VILLAGE OF GERMANTOWN
N112 W17001 MEQUON ROAD
GERMANTOWN, WI 53022

MEETING:	PLAN COMMISSION
DATE AND TIME:	MONDAY, JULY 23, 2018 6:30 p.m.
LOCATION:	Germantown Village Hall Board Room

7/23/18 Plan Commission Meeting

Village Planner Report

SHEET C-16 OF C-22

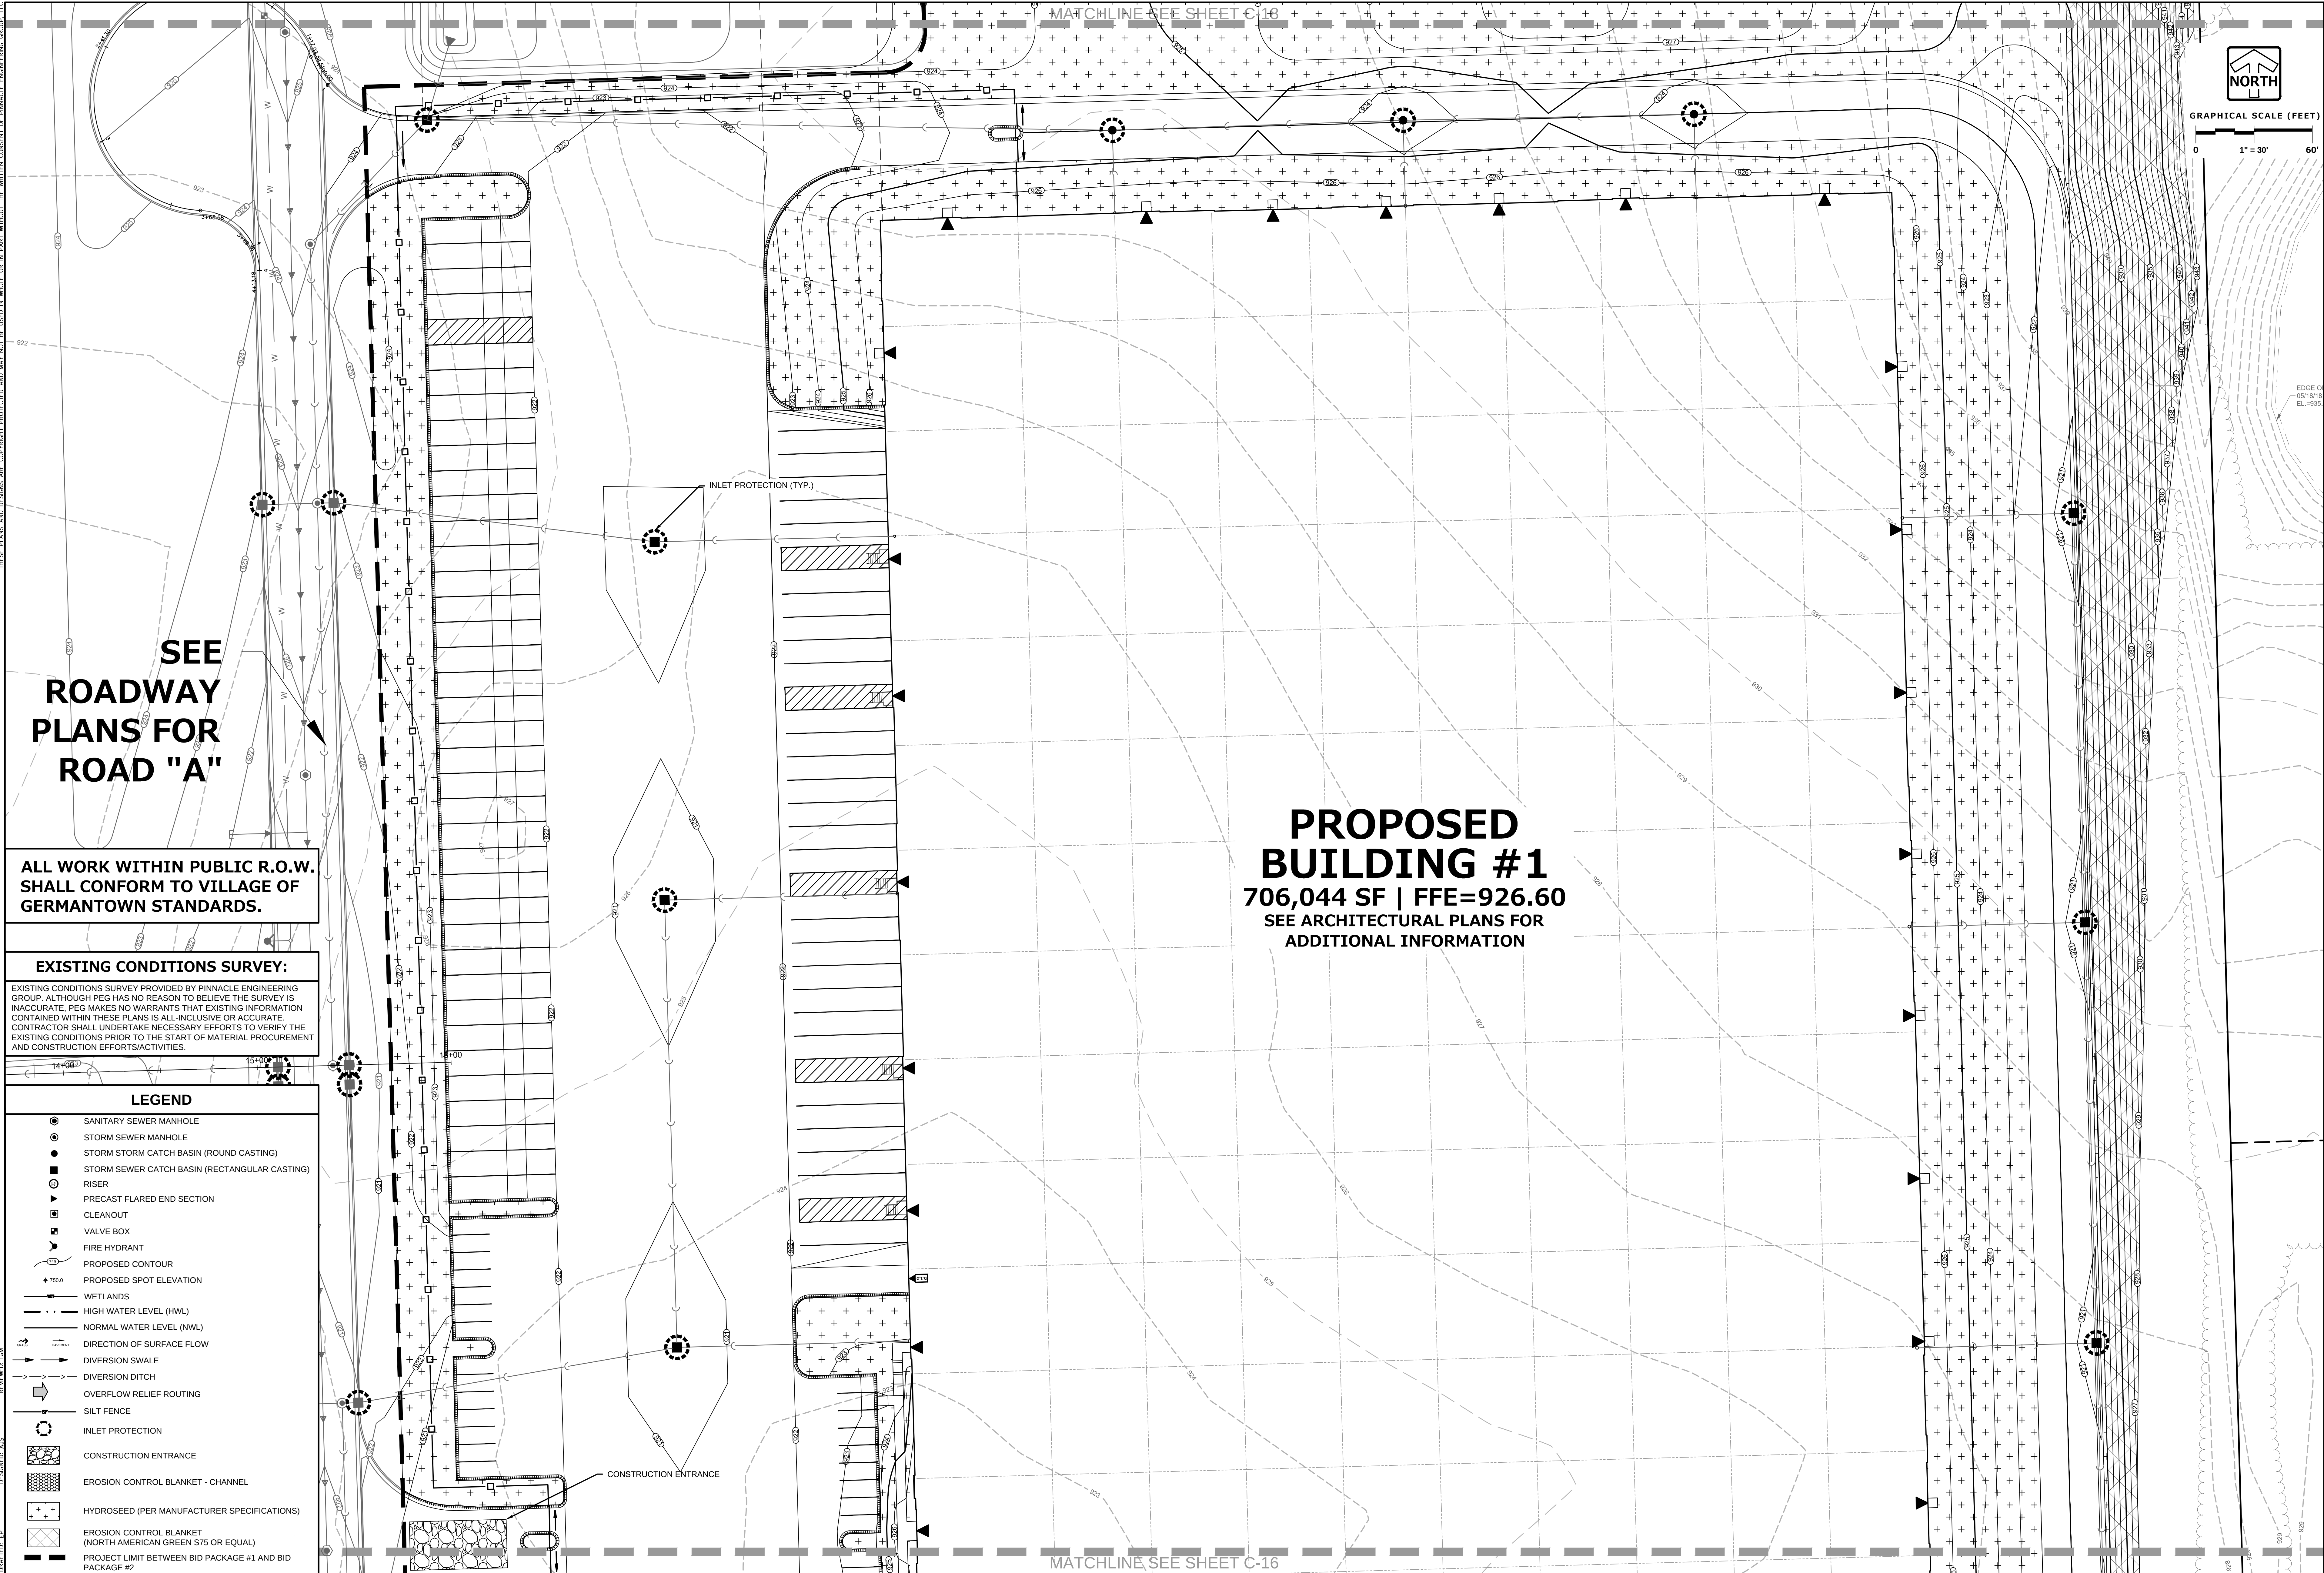
4. Extend limits of erosion matting to cover the entire sloped area on the east side of the site.
Additional erosion matting has been added cover the entire sloped area on the east side. See sheet C-16

SHEET
L-1
of
L-5

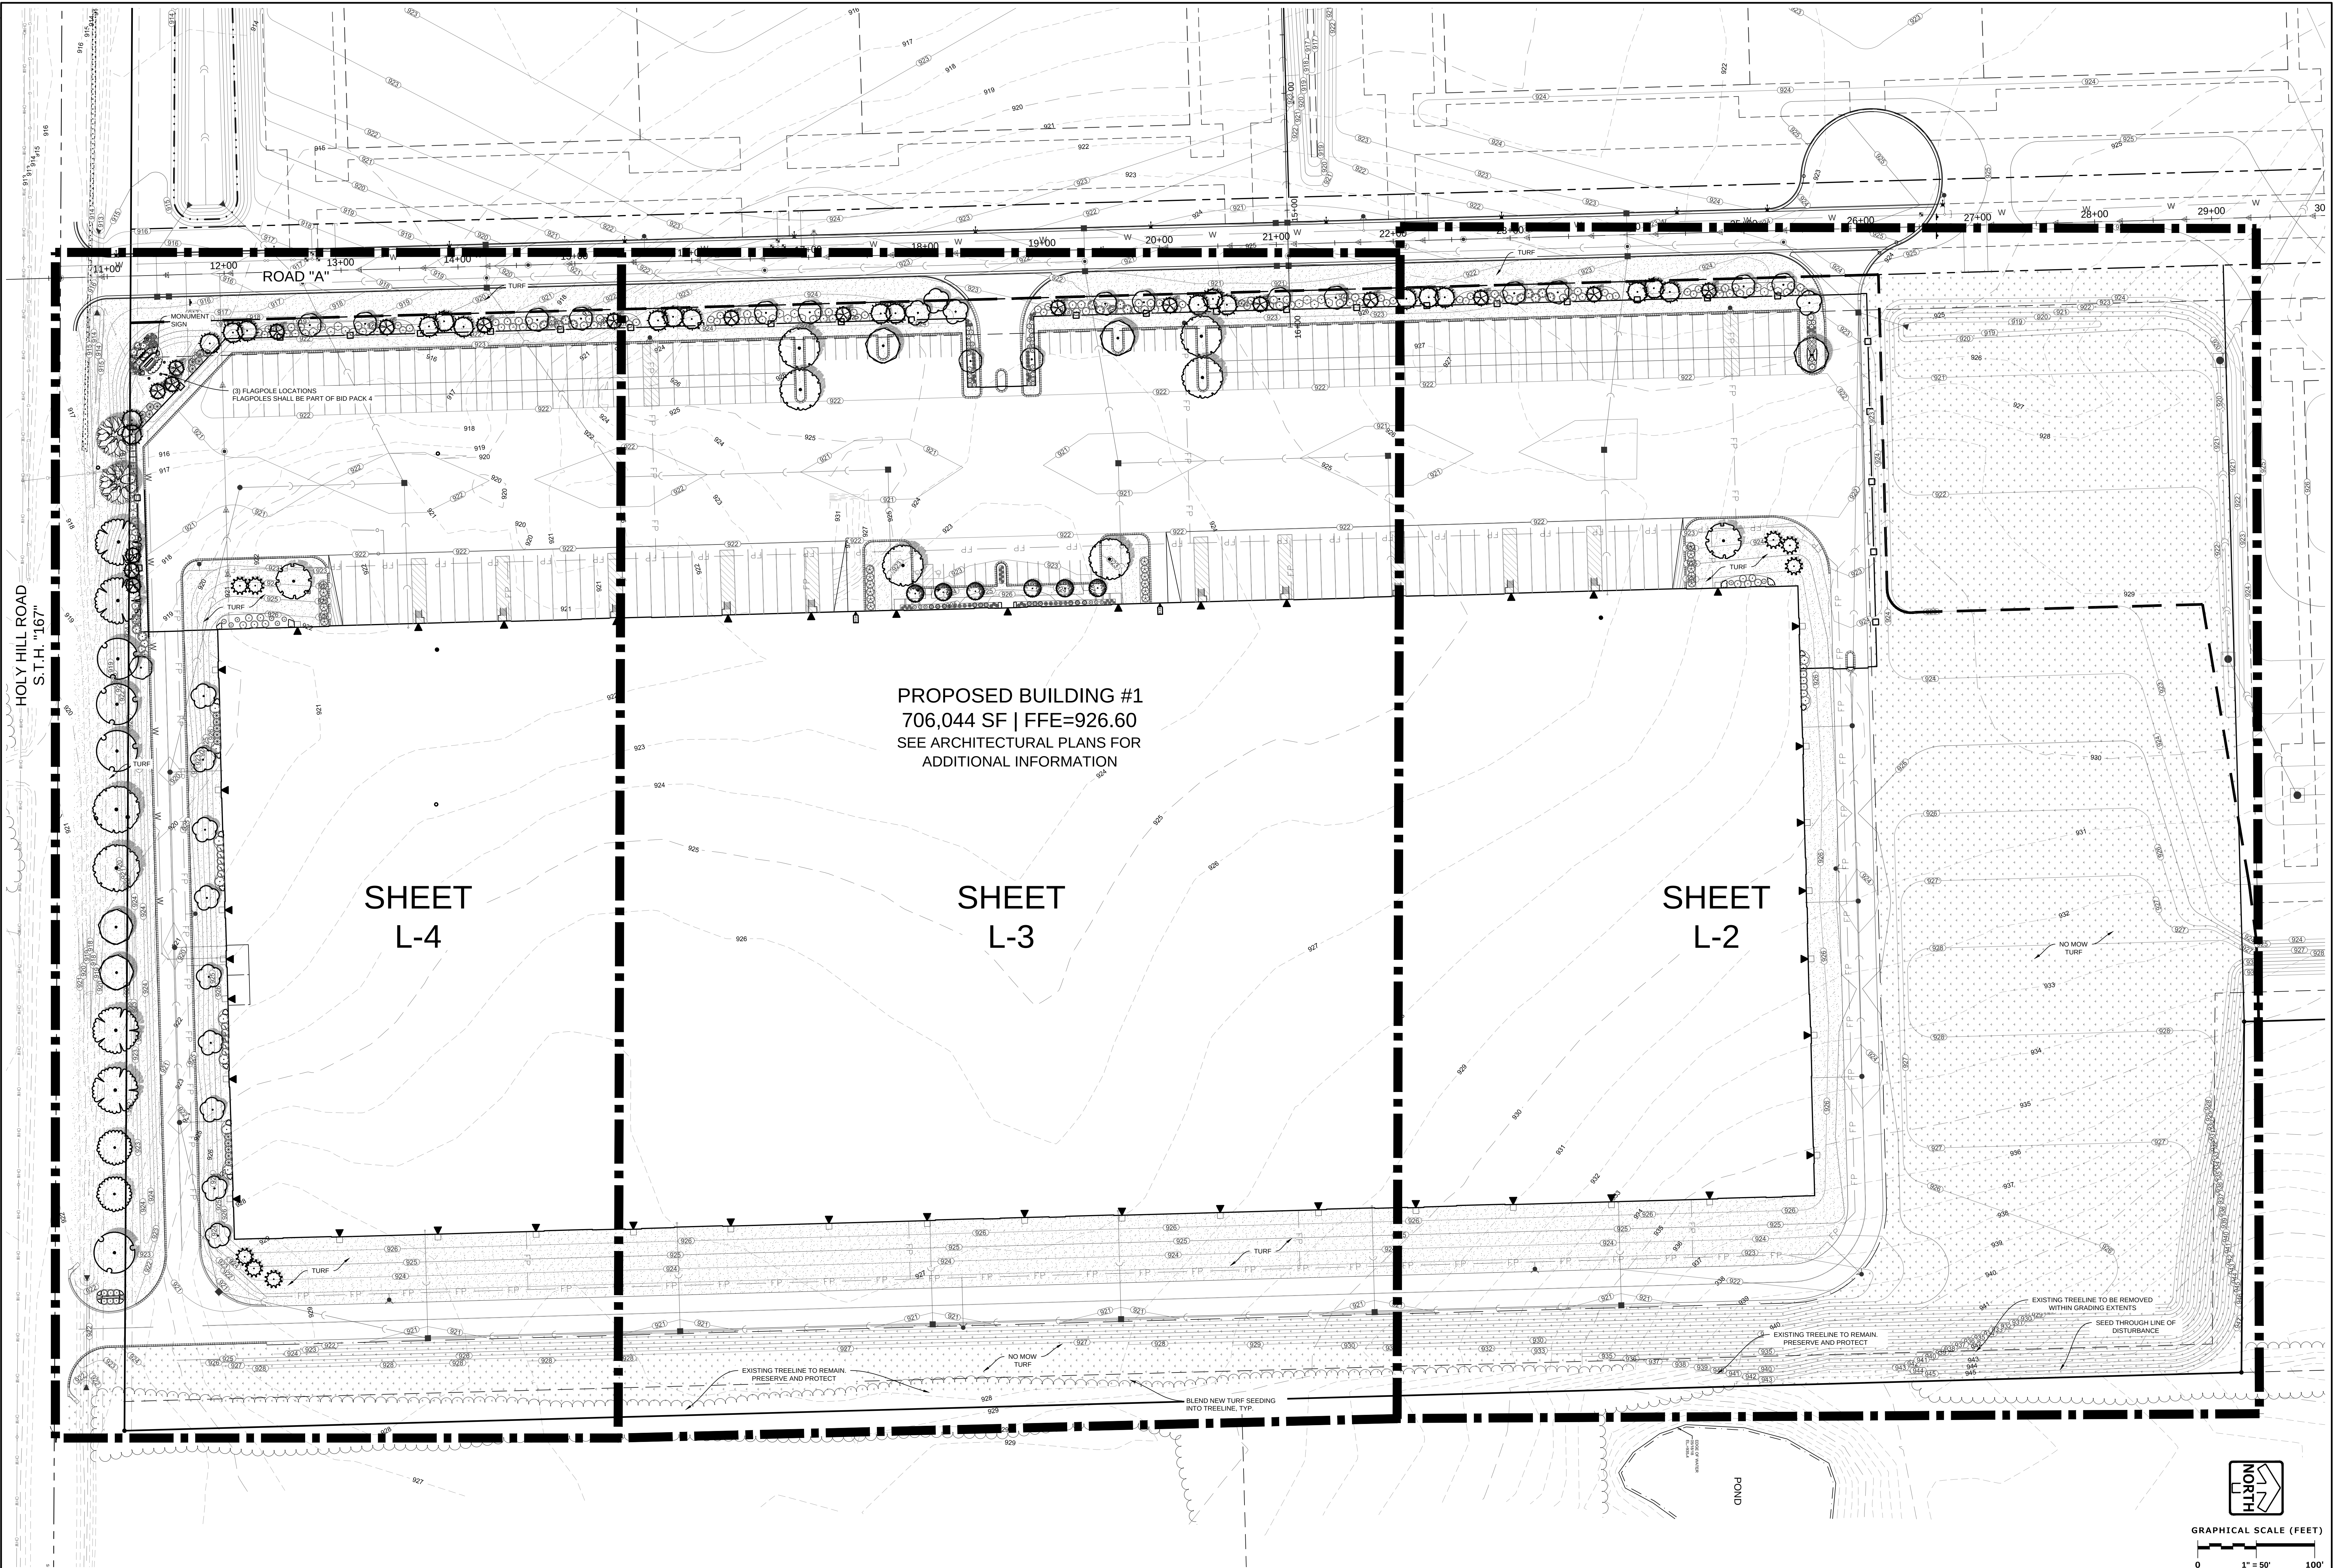
11. The property line location (after right-of-way dedication for Holly Hill Road) shown on various sheets including Sheet L-1 & L-4 is incorrectly shown... it looks like an errant property line from the previous residential lot is being shown for a short distance instead of the correct property/ROW line.
